WINSTAR Display Co.,Ltd.

■ Subject of Change: IC Vendor informed PCN driver IC SC7283-G4

■ Issue Date : July. 15th, 2021

■ Effect of Change: WF43W,WJ43B,WJ43C,WJ43Y Series

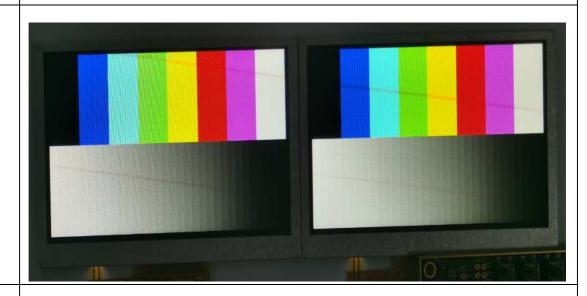
■ Description: Due to original IC wafer capacity is completed full, IC vendor change wafer production. Also, we modified the VDDI range and added a set of capacitors from VCC to ground to strengthen the ESD ability..

Panel Parts No.	Before Change ICSC7283321XXXXXXX00	After Change ICSC7283321XXXXXXX01
WS Module Parts No.	WF43W,WJ43B,WJ43C,WJ43Y Series	
FPC Appearance (FPC has been modified with the circuit according to the supplier's recommendations)	ROHS ROHS ROM ROM ROM ROM ROM ROM ROM RO	PS2TOVOAR300WA2G1X00 @B VOOM 1000 BHR000 CS SOA ATOL ATOL GOLD GOLD GOLD GOLD GOLD GOLD GOLD GO
Module
